**Re: ODOARDI – Vacant Lot  
22 Nethermont Ave. – New House Construction  
Tax ID: Section 122.16 – Block 4 – Lot 7**

G.E.S Revisions/Written Response to Comments addressing the comments received 03/18/2021

G.E.S Revisions/Written Response to Comments addressing the Planning Board Staff Report, dated January 24, 2020, and Revisions/Written Response to Comments Received from Kellard Sessions (Town Consulting Engineer), dated January 24, 2020.

PROPOSED RESIDENCE WITH ADDITION TO GARAGE  
22 NETHERMONT AVE

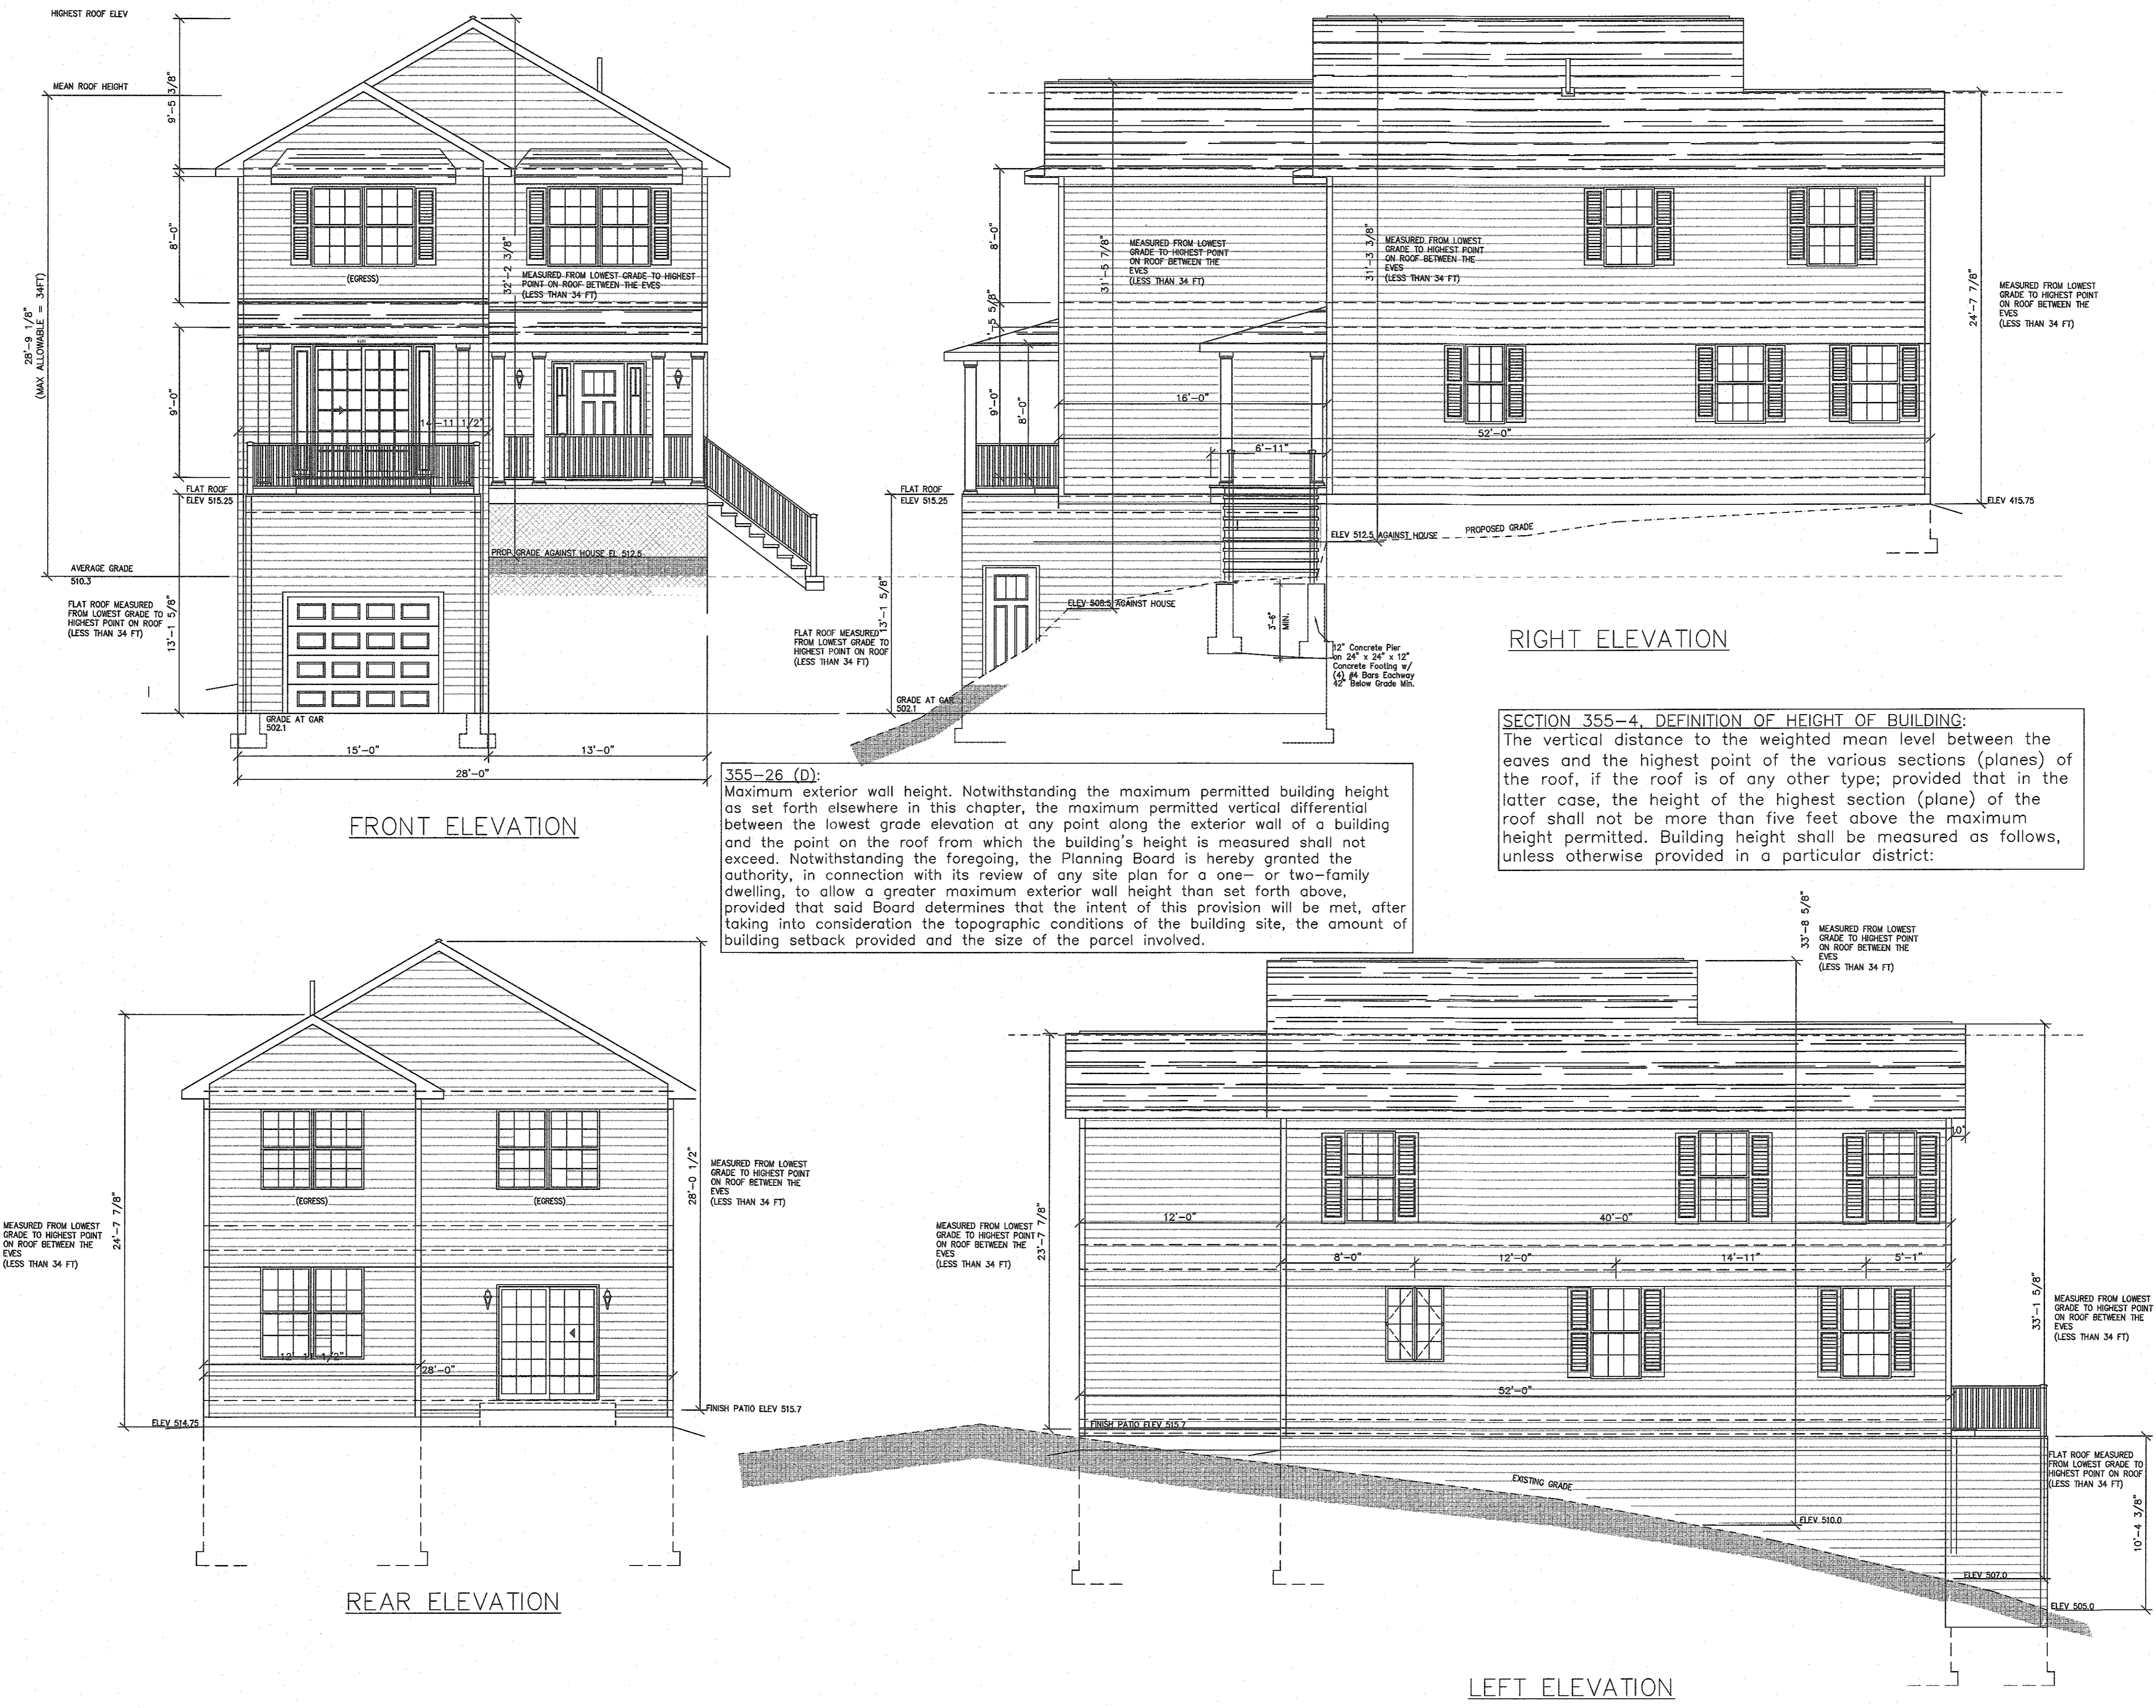
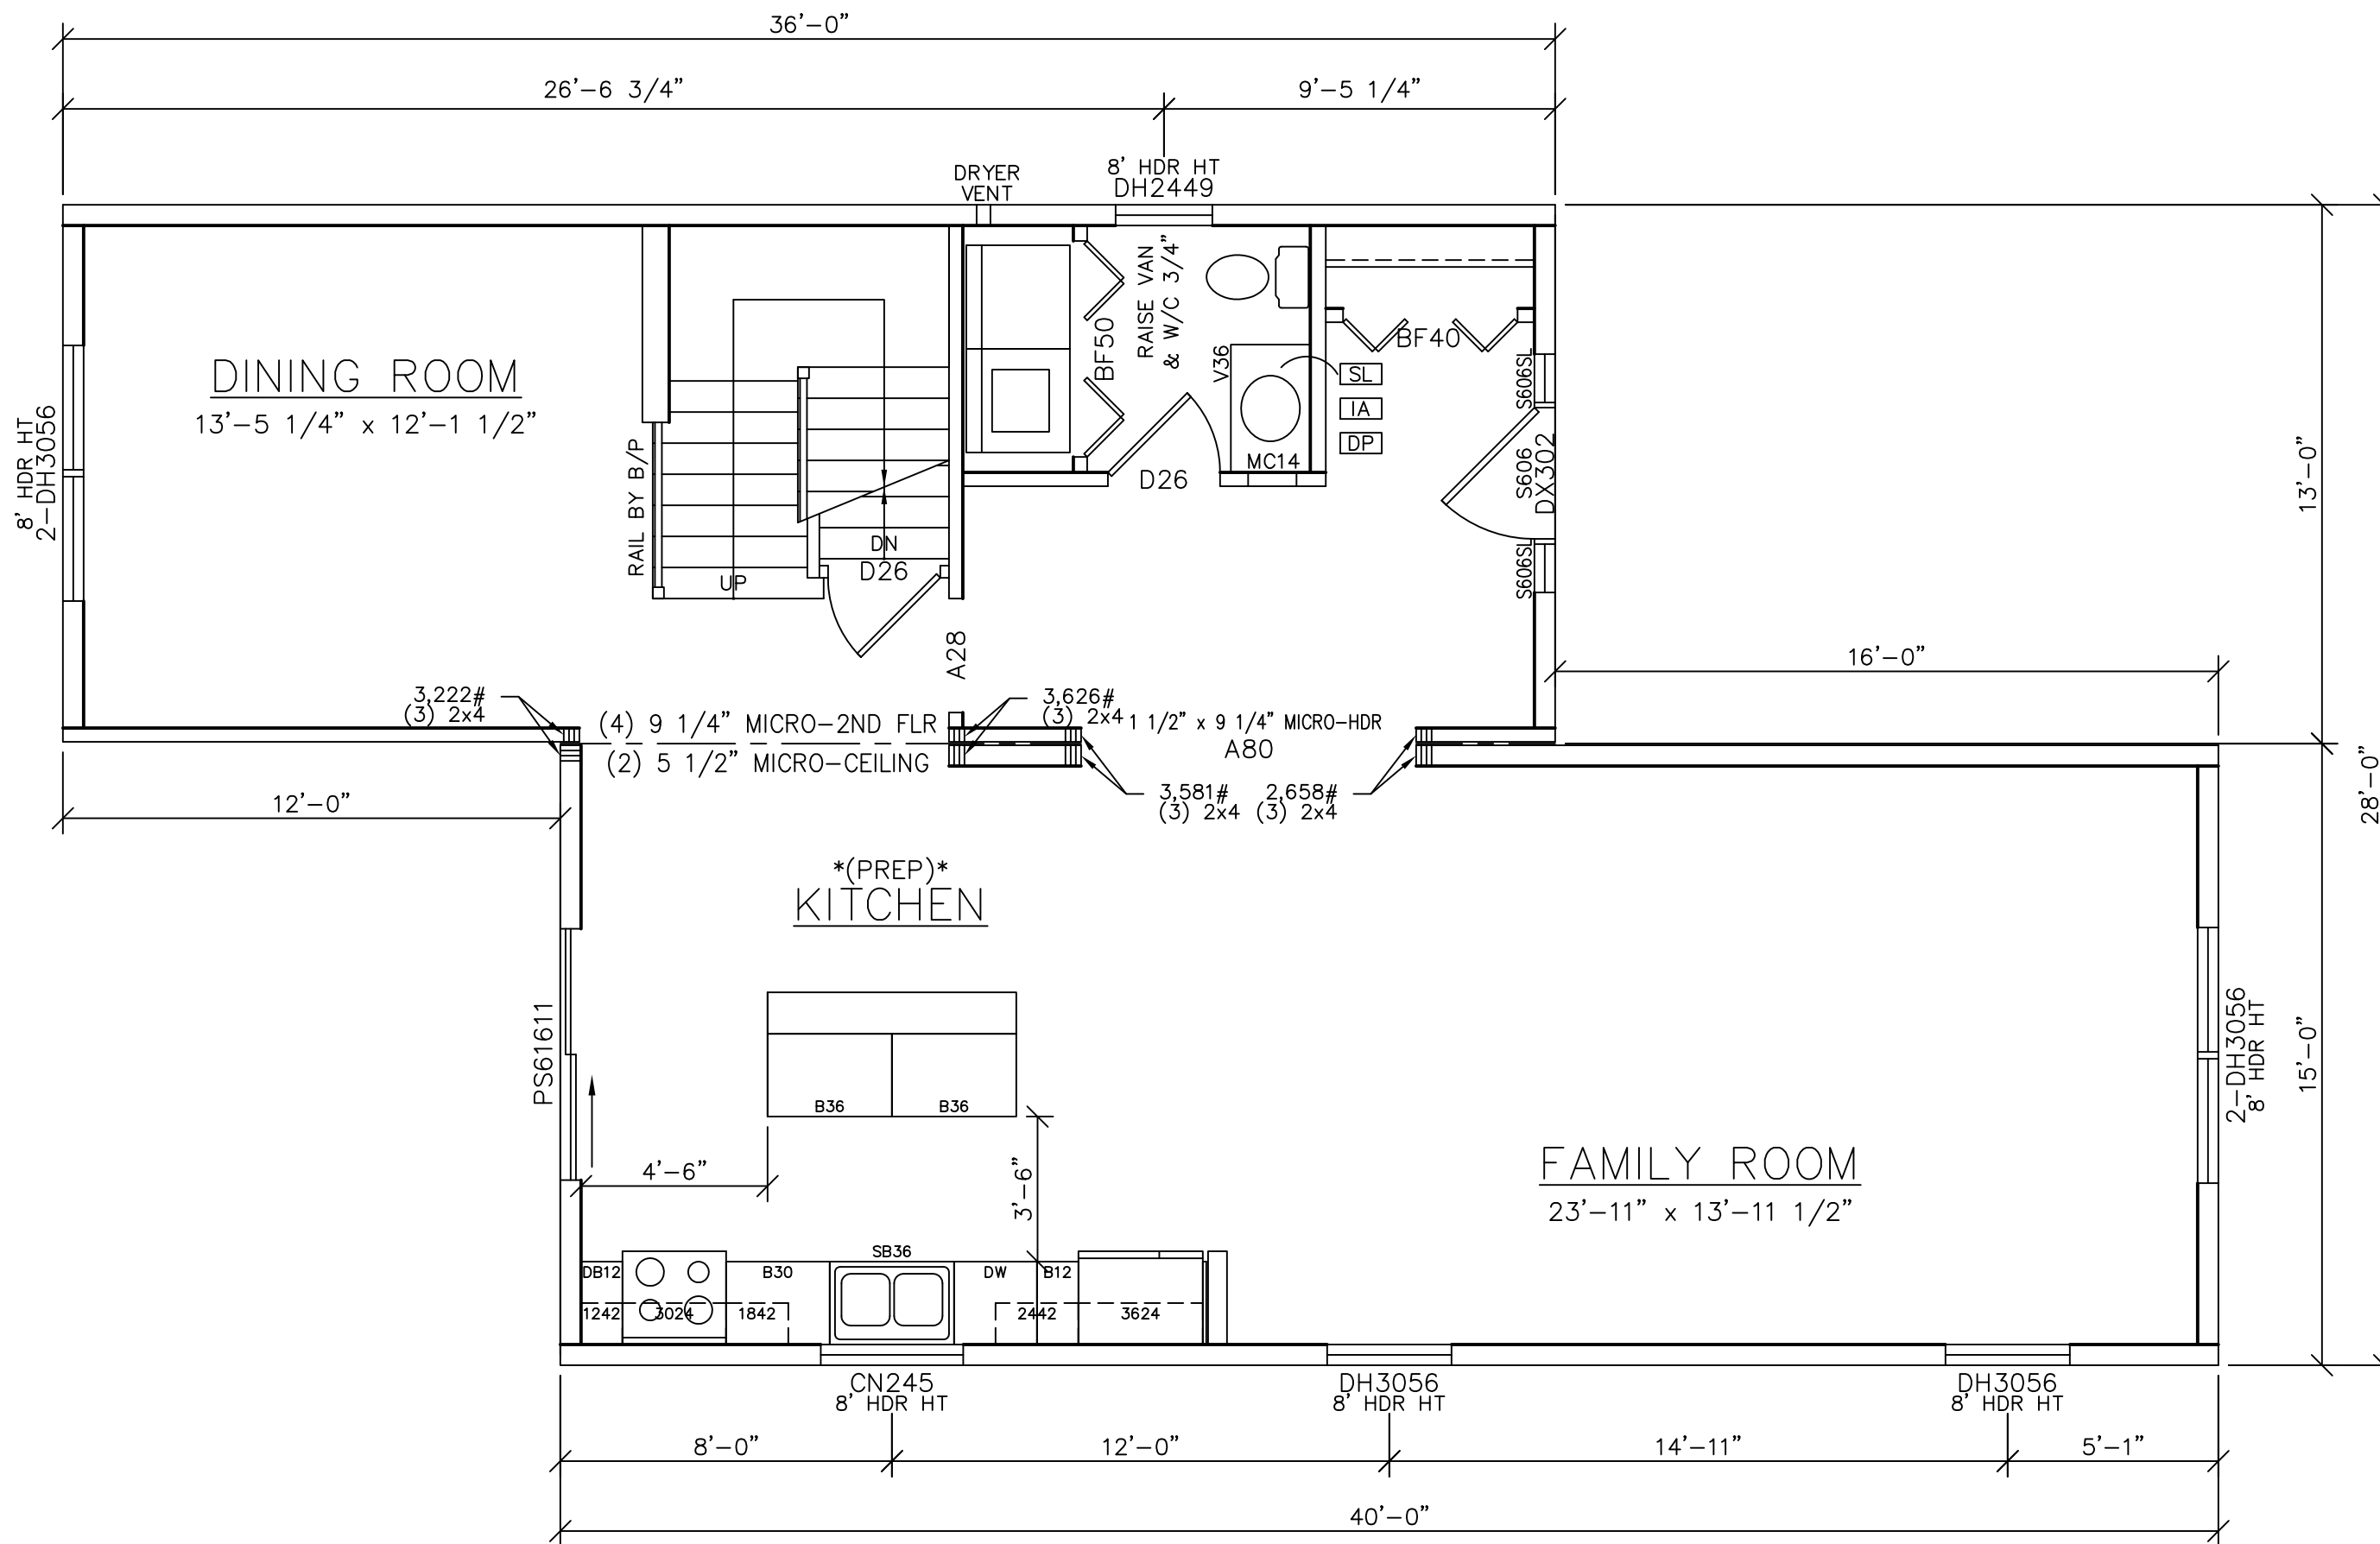
- Separate Plan sheets have been created for clarity.
  4. As previously requested, the applicant shall demonstrate zoning compliance with respect to building height. As defined by Town Code, the average grade used to determine building height in cases where the finished ground level slopes away from the exterior walls, as this does, the average grade shall be the lowest point within six (6) feet from the perimeter of the building. The applicant has provided average grade calculations; however, it appears that the elevations were taken immediately adjacent to the building. The calculation and supporting data should be revised accordingly and verified by the Building Inspector.

- Building Height Schematics are attached.
  5. As previously requested, the applicant shall provide a maximum wall height calculation to demonstrate compliance with Section 355-26 D, which limits height to 34 feet for the R-5, One-Family Residence Zoning District. Based on the building elevations provided, and the need to verify the average grade as noted above, the maximum wall height calculation should be provided to the Building Inspector for verification that an area variance would not be required.

- Ok
8. The Applicant should provide a building height exhibit for review.
  - A building height exhibit has been provided. See sheet BH-1 of the submittal.
